UNITED STATES PATENT AND TRADEMARK OFFICE

APPLICATION NO.	FILING DATE	FIRST NAMED INVENTOR	ATTORNEY DOCKET NO.	CONFIRMATION NO.
10/605,234	09/17/2003	Chih-Han Chang	NTCP0004USA	3393

Office Action Summary	Application No. 10/605,234	Applicant(s) CHANG ET AL.	
	Examiner Khiem D. Nguyen	Art Unit 2823

DETAILED ACTION

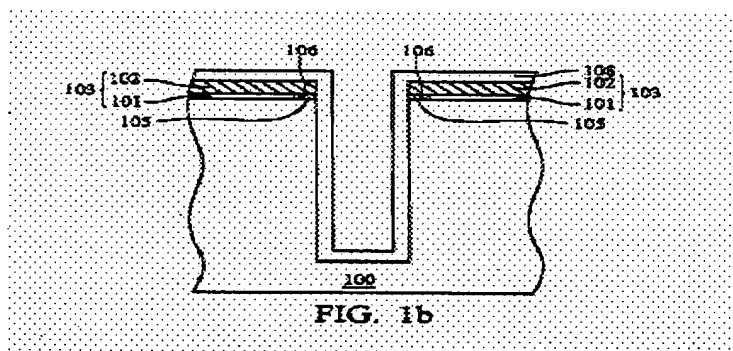
In re claim 1, **Chen** discloses a method for forming a deep trench capacitor buried plate comprising: providing a substrate 100 having a pad oxide 101 and the pad nitride layer 102 thereon, the pad oxide layer 101 and a pad nitride 102 layer having at least an opening; performing a dry etching process for forming a deep trench 104 in the substrate 100 via the opening (col. 3, lines 16-34 and FIG. 1a);

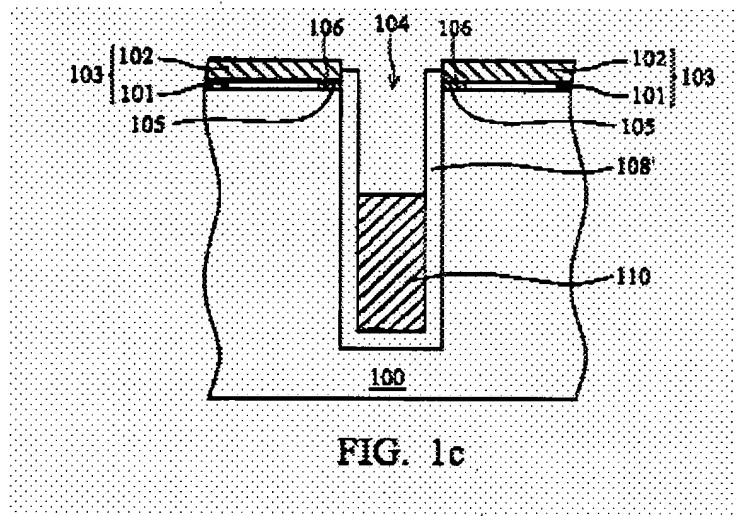
depositing a doped silicate glass film 108 on an inner wall of the deep trench 100 (col. 3, lines 35-47 and FIG. 1b);

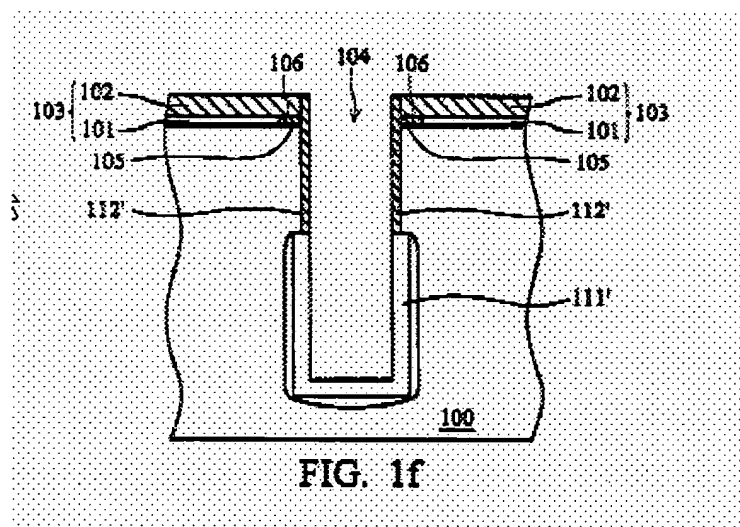
filling a sacrificial layer into the deep trench 104 (col. 3, lines 48-58); etching back the sacrificial for exposing parts of the doped silicate glass film 108 (col. 3, lines 48-58 and FIG. 1c);

FIG. 1g

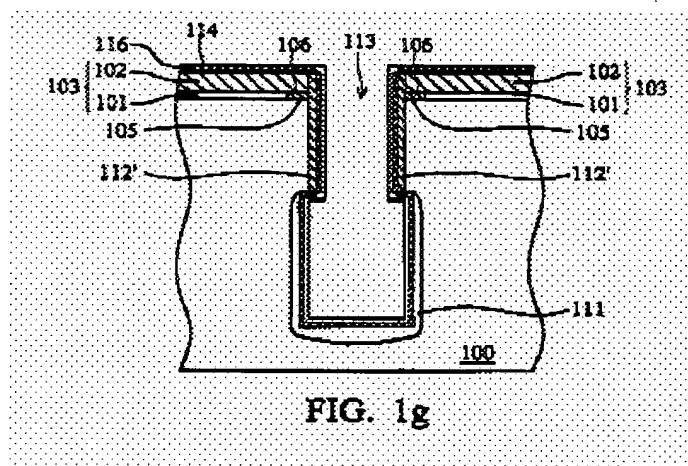
depositing a silicon nitride layer 112' on the inner wall of the deep trench 104 (col. 3, lines 66-67); performing a thermal process for forming a doped region 111 at a bottom of the trench 104 (col. 4, lines 1-7 and FIG. 1g);

wherein the silicon nitride layer 112' serves as a barrier layer for preventing ions of the doped silicate glass film 108 from diffusing into a collar region of the deep trench 104 (col. 4, lines 1-7 and FIG. 1g).

FIG. 1i

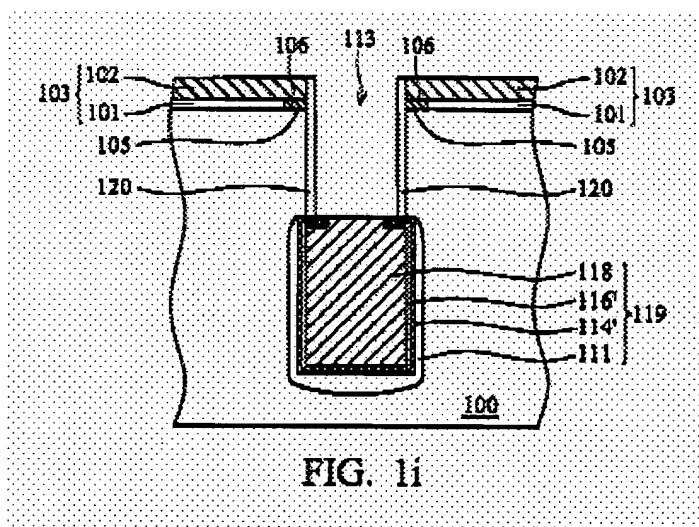
removing the silicon nitride layer 112' (col. 4, lines 8-14 and FIG. 1i); and removing the doped silicate glass film (col. 4, lines 14-20 and FIG. 1i);

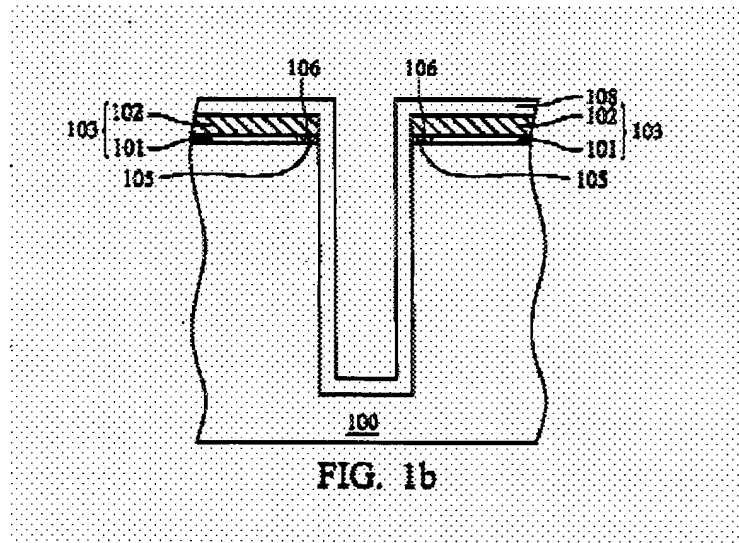
In re claim 7, Chen discloses a method for forming a deep trench capacitor buried plate comprising: providing a substrate 100 having a pad oxide 101 and the pad nitride layer 102 thereon, the pad oxide layer 101 and a pad nitride 102 layer having at least an opening; performing a dry etching process for forming a deep trench 104 in the substrate 100 via the opening (col. 3, lines 16-34 and FIG. 1a);

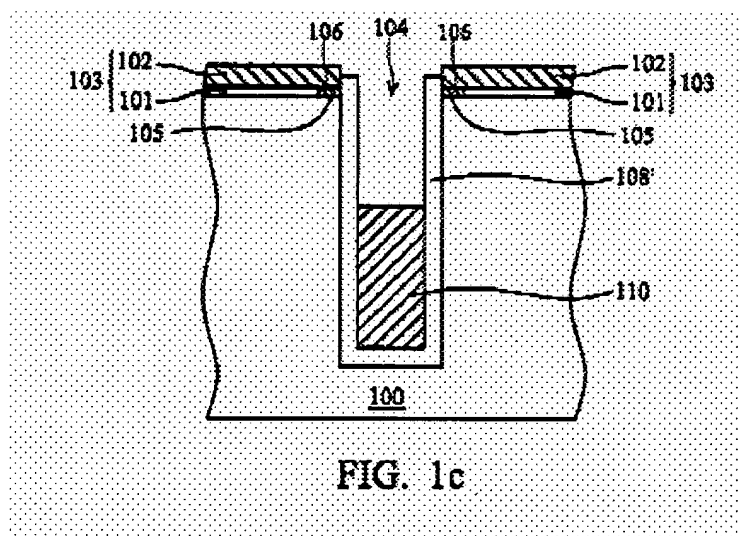
depositing a doped silicate glass film 108 on an inner wall of the deep trench 100
(col. 3, lines 35-47 and FIG. 1b);

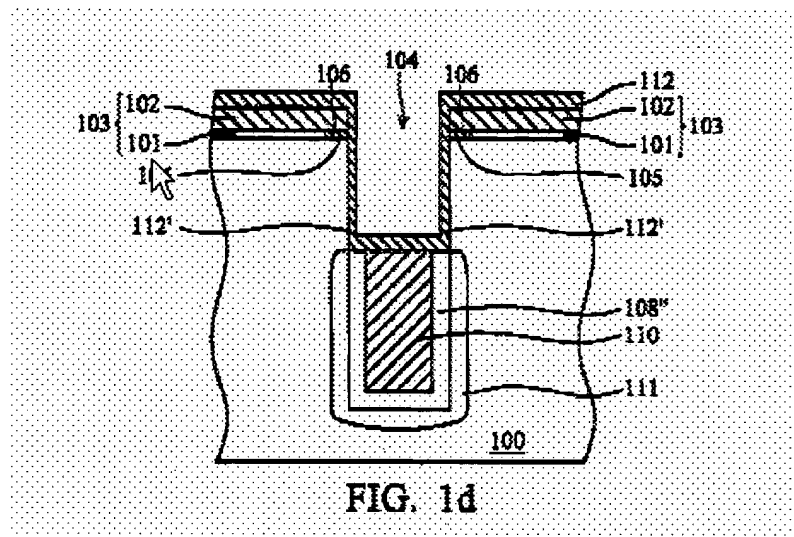
filling a sacrificial layer into the deep trench 104 (col. 3, lines 48-58); removing a portion of the sacrificial for exposing parts of the doped silicate glass film 108 (col. 3, lines 48-58 and FIG. 1c);

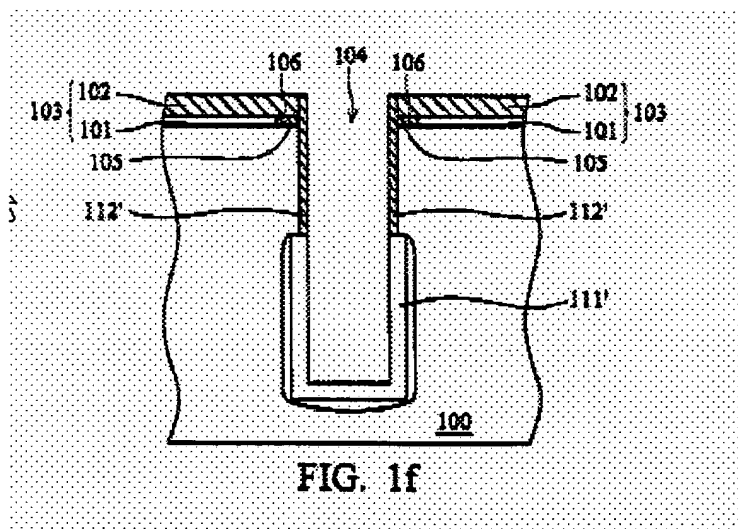
performing an etching process to remove the exposed doped silicate glass film 108 and a portion of the pad oxide layer 101 for forming a recess 105 (col. 3, lines 59-66 and FIG. 1d);

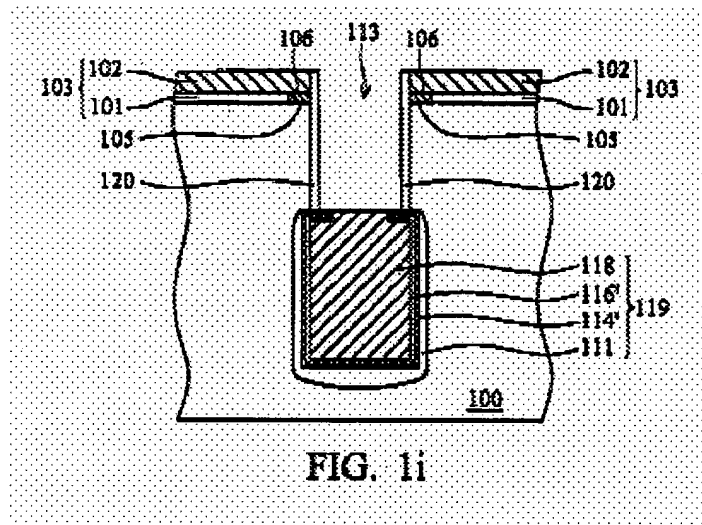
depositing a silicon nitride layer 112' on the inner wall of the deep trench 104 (col. 3, lines 66-67); performing a diffusing process for forming a doped region 111 at a bottom of the trench 104 (col. 4, lines 1-7 and FIG. 1g);

wherein the silicon nitride layer 112' serves as a barrier layer for preventing ions of the doped silicate glass film 108 from diffusing into a collar region of the deep trench 104 (col. 4, lines 1-7 and FIG. 1g).

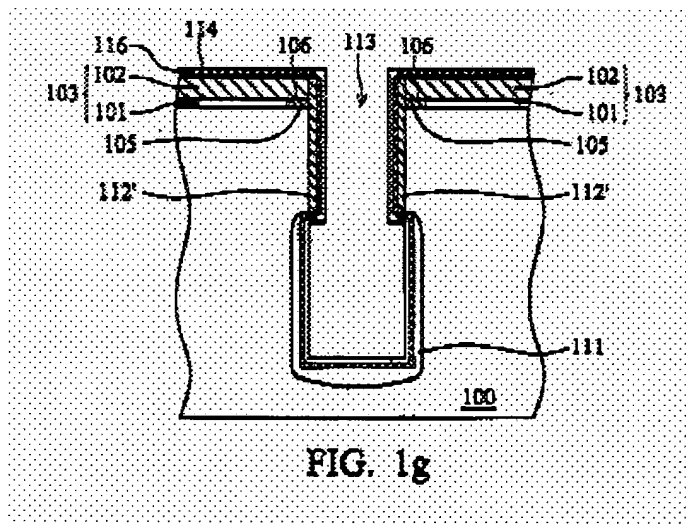
removing the silicon nitride layer 112' (col. 4, lines 8-14 and FIG. 1i); and
 removing the doped silicate glass film (col. 4, lines 14-20 and FIG. 1i);

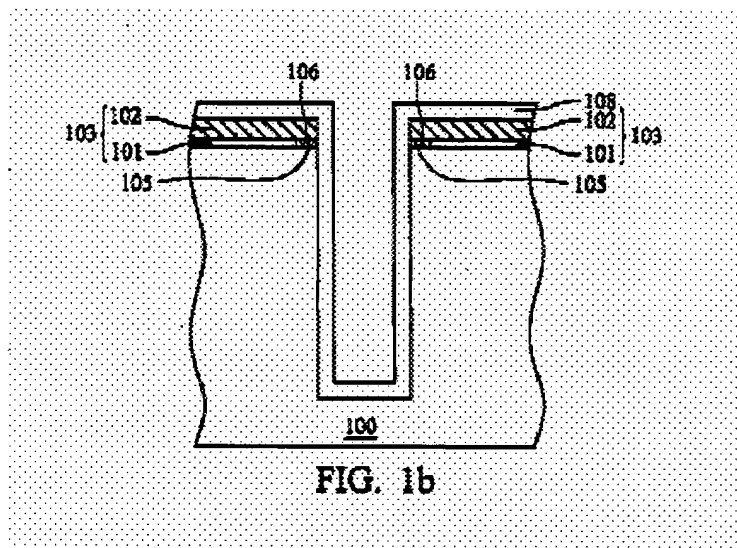
In re claim 13, Chen discloses a method for forming a deep trench capacitor comprising: providing a substrate 100 having a pad oxide layer 101 and a pad nitride layer 102 thereon, the pad oxide layer 101 and a pad nitride layer 102 having at least an opening; performing a dry etching process for forming a deep trench 104 in the substrate via the opening (col. 3, lines 16-34 and FIG. 1a);

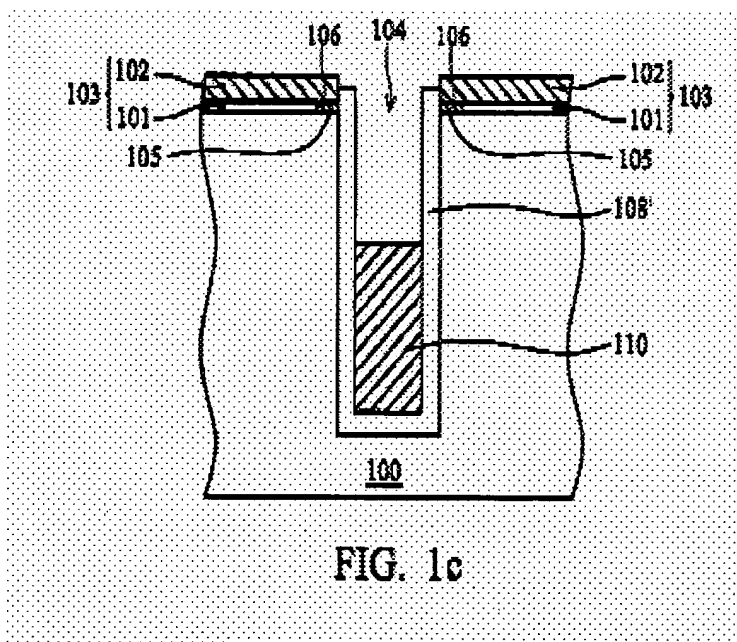
depositing a doped silicate glass film 108 on an inner wall of the deep trench 100
(col. 3, lines 35-47 and FIG. 1b);

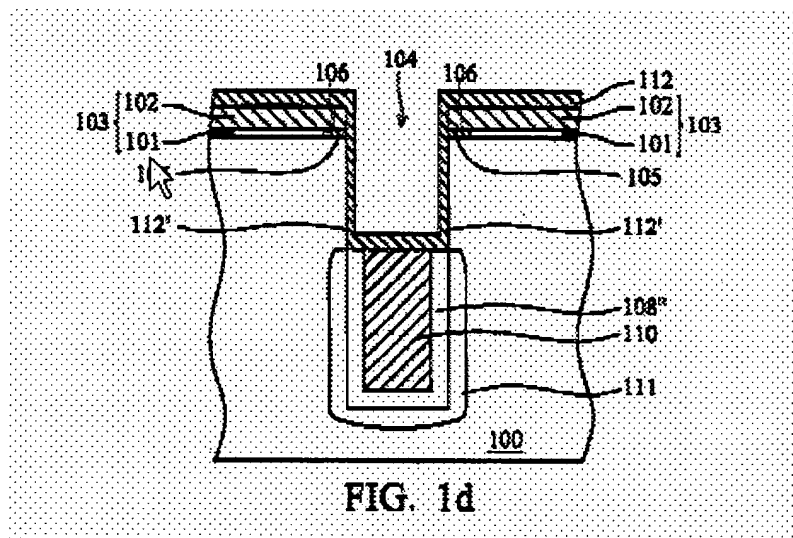
filling a sacrificial layer into the deep trench 104 (col. 3, lines 48-58); etching
back the sacrificial for exposing parts of the doped silicate glass film 108 (col. 3, lines
48-58 and FIG. 1c);

removing the exposed doped silicate glass film 108 (col. 3, lines 59-66 and FIG.

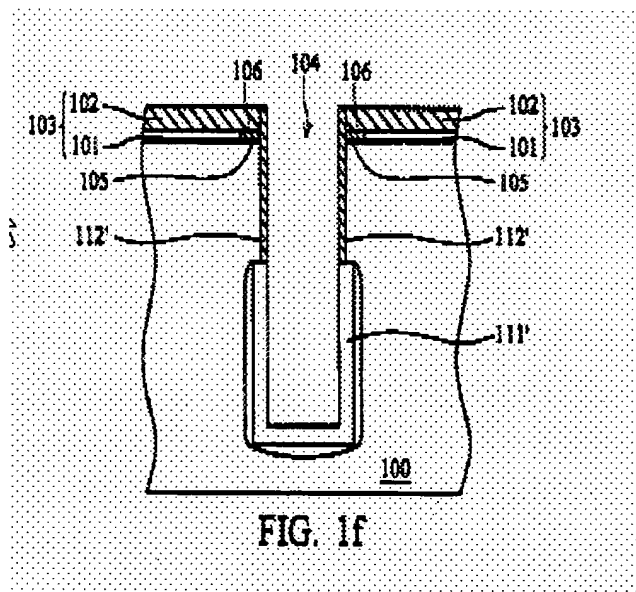
removing the remaining sacrificial layer (FIG. 1f);

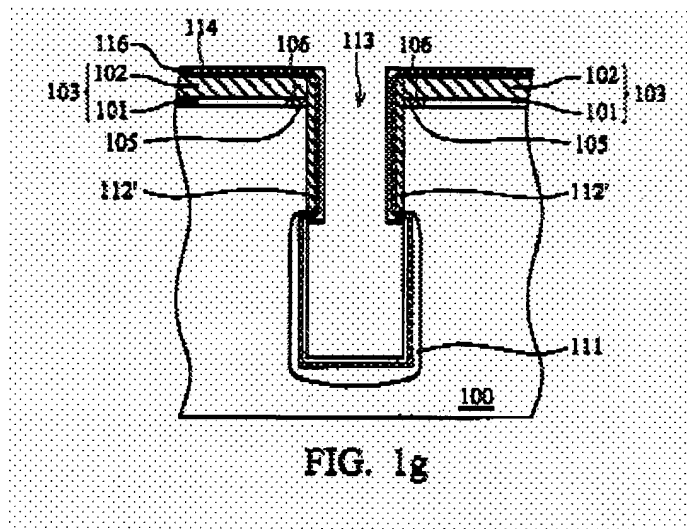
depositing a silicon nitride layer 112' on the inner wall of the deep trench 104 (col. 3, lines 66-67) after removing the remaining sacrificial layer; performing a thermal

process for forming a doped region 111 at a bottom of the trench 104 (col. 4, lines 1-7 and FIG. 1g);

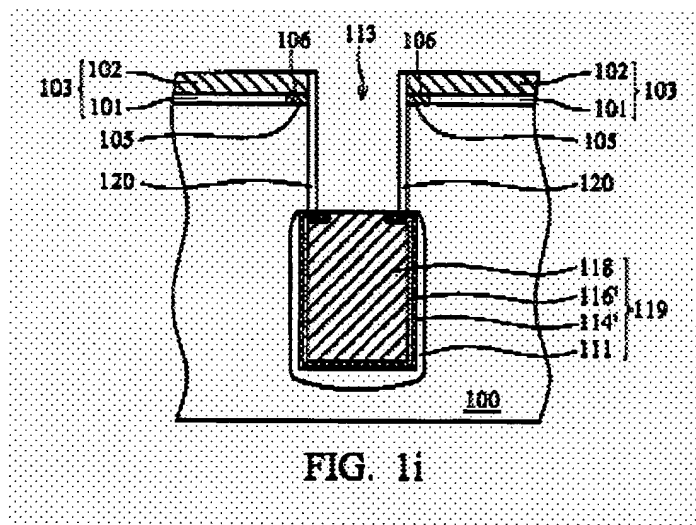
removing the silicon nitride layer 112'; and removing the doped silicate glass film 108 (col. 4, lines 14-20 and FIG. 1i).
